Nuclear Management Company, LLC
Prairie Island Nuclear Generating Plant
1717 Wakonade Dr. East
Welch MN 55089

PRAIRIE ISLAND NUCLEAR GENERATING PLANT
Docket Nos. 50-282 License Nos. DPR-42
50-306 DPR-60

**Supplement to License Amendment Request dated December 11, 2000
Conversion to Improved Technical Specifications (ITS)**

1. NRC RAIs Specification 3.3.3, "Event Monitoring (EM) Instrumentation", Specification 3.3.4, "4 kV Safeguards Bus Voltage Instrumentation", and Specification 3.3.5, "Containment Ventilation Isolation Instrumentation", and NMC Responses.
2. Page List by RAI Q
3. Revision 7 Change Pages

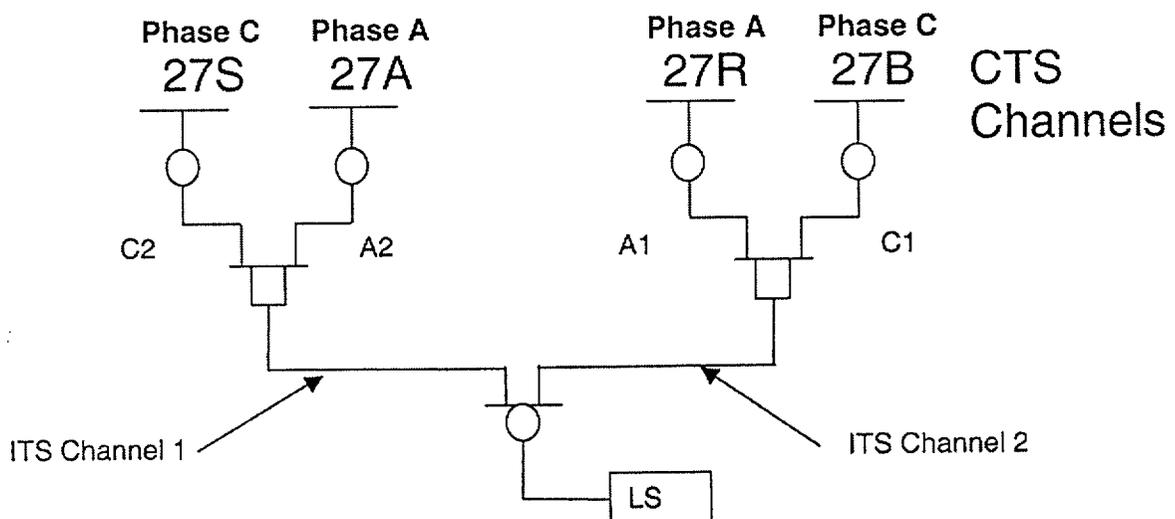
RAI 3.3.4- Undocumented change -#2, page 32 of 72 (Part C)

Provide a Discussion of Change for deleting CTS channels per phase and phases per bus requirements in Table 3.5-2B, Loss of Power Functions 8.a and 8.b.

CTS Table 3.5-2B, Function 8 requires 4 channels per bus, 2 per phase on 2 phases for both the Degraded Voltage (DV) sub-Function 8a and Undervoltage (UV) sub-Function 8b. ITS LCO 3.3.4 requires 2 channels per bus for both DV and UV Functions. As will be demonstrated in the following discussion, the redefinition of channels along with the associated Required Actions (RAs) either bound or are functionally equivalent to the CTS channels and their associated Actions. These changes make the Technical Specifications more technically correct and consistent with other safeguards logic channels. Unlike most other safeguards protection logic channels, the 4 kV DV and UV CTS channels are not designed to interact equally. For example, in the Reactor Trip System logic, when two out of four channels are required for actuation, any two channels can combine to initiate actuation. As discussed below, redefining the 4 kV protection channels in ITS make these channels more consistent with other logic schemes and more consistent with NUREG-1431.

Eight relays provide the inputs to the 4 kV DV and UV functions for each bus. Four relays per bus provide input to the DV function and four relays per bus provide input to the UV function. The sketch below is representative of the logic for both of these Functions on both buses. Two phases on each bus have two relays, labeled in the sketch as Phase A and Phase C. The input from the four relays, A1, A2, C1 and C2, shown on the sketch are the four channels per bus required by CTS. Input from A1 and A2 are the 2 channels for Phase A and input from C1 and C2 are the 2 channels for Phase C as required by CTS.

ITS has redefined the channels as shown on the sketch as ITS channels 1 and 2. The input from relays A1 and C1 combine in the AND-logic to provide ITS channel 1 input to the actuation circuitry. Likewise, input from relays A2 and C2 combine in the AND-logic to provide ITS channel 2 input to the actuation circuitry. These two channels satisfy the ITS requirement for two channels per bus. If one ITS channel is inoperable, LCO 3.3.4 RA A.1 requires placing the channel in bypass which means this channel will not provide input to the actuation circuitry. This is functionally equivalent to CTS Action 31 because when one CTS channel input to the AND-logic is bypassed, that AND-logic will not provide input to the actuation circuitry. If two ITS channels are inoperable, LCO 3.3.4 RAs B.1 through B.4 specify actions to be taken to place the plant in a safe condition equivalent to CTS Action 33.
